ST/SG/AC.10/29/Add.2  
17 February 2003

**REPORT OF THE COMMITTEE OF EXPERTS ON THE TRANSPORT OF  
DANGEROUS GOODS AND ON THE GLOBALLY HARMONIZED SYSTEM OF  
CLASSIFICATION AND LABELLING OF CHEMICALS  
ON ITS FIRST SESSION**

**Addendum 2**

**Amendments to the third revised edition of the Recommendations on the Transport of Dangerous Goods, Manual of Test and Criteria**

**Figure 10.2: PROCEDURE FOR PROVISIONAL ACCEPTANCE OF A SUBSTANCE OR ARTICLE IN CLASS 1**

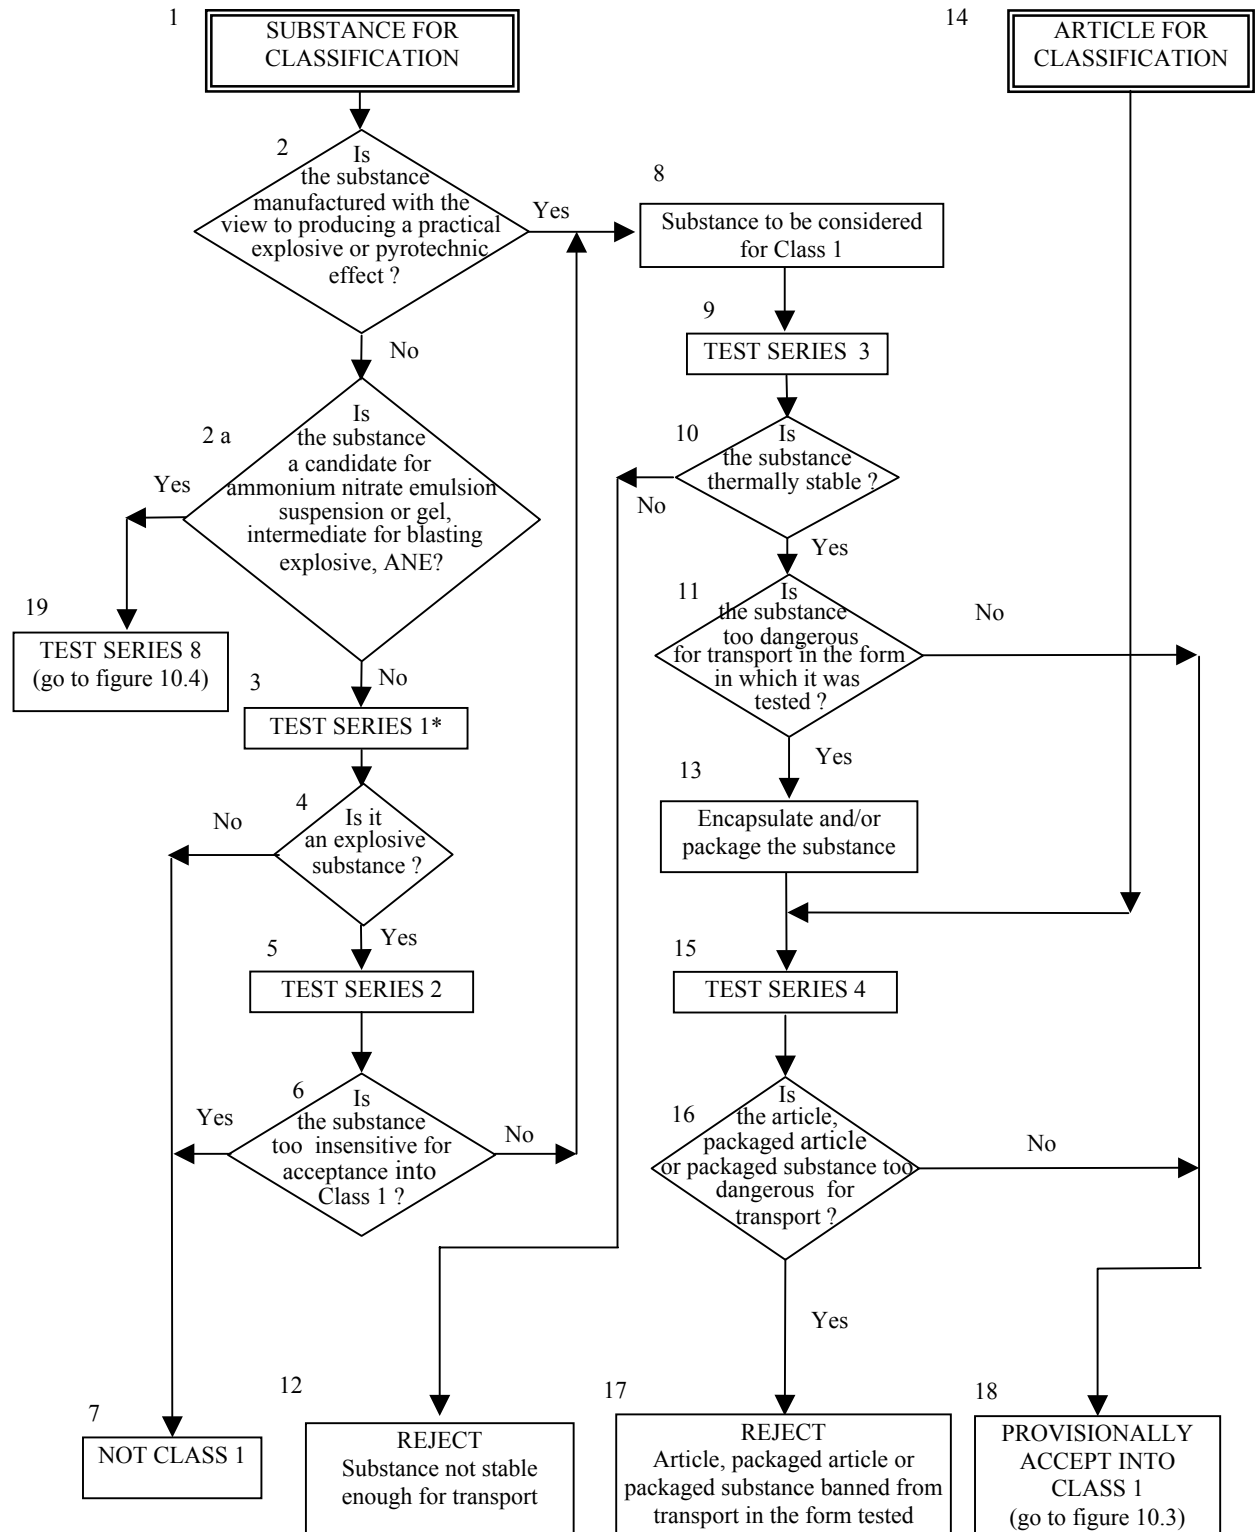
Figure 10.2 Amend this figure as shown in page 3 of this document.

Figure 10.4

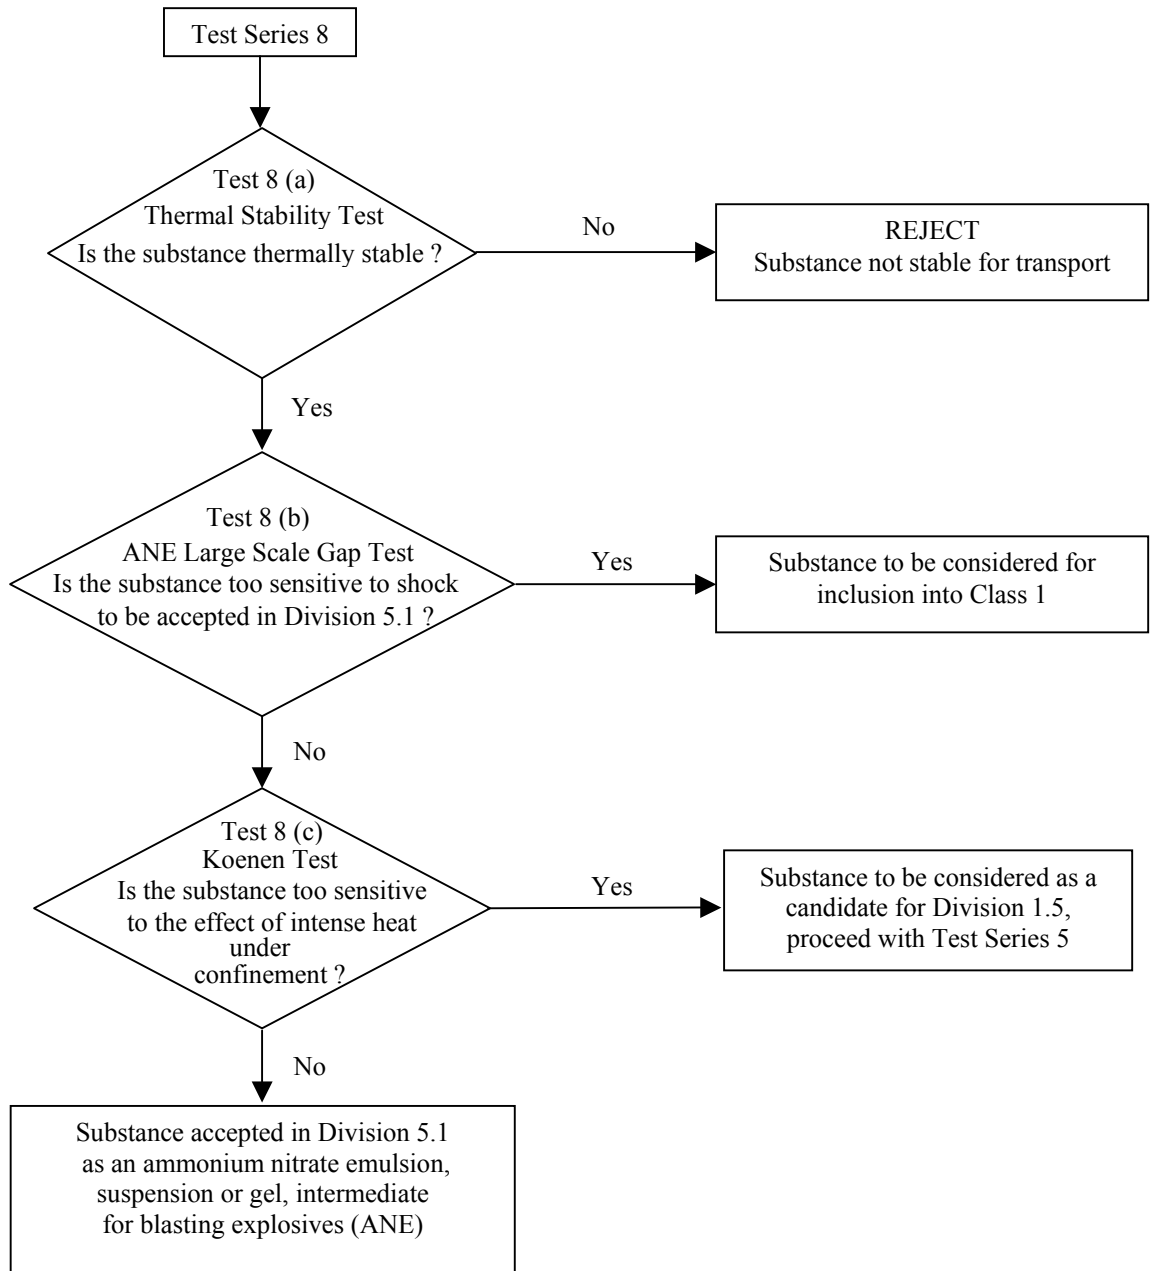
Figure 10.4 Insert a new figure 10.4, as shown in page 4 of this document, immediately after the existing Figure 10.3 and renumber the Figures 10.4 to 10.8 consequently.

"10.4.3.7 Test types 8 (a) to 8 (c) should be used to establish whether an ammonium nitrate emulsion or suspension or gel, intermediate for blasting explosives (ANE) may be assigned to Class 5.1. Substances failing any of the tests may be considered as a candidate for Class 1 in accordance with figure 10.4."
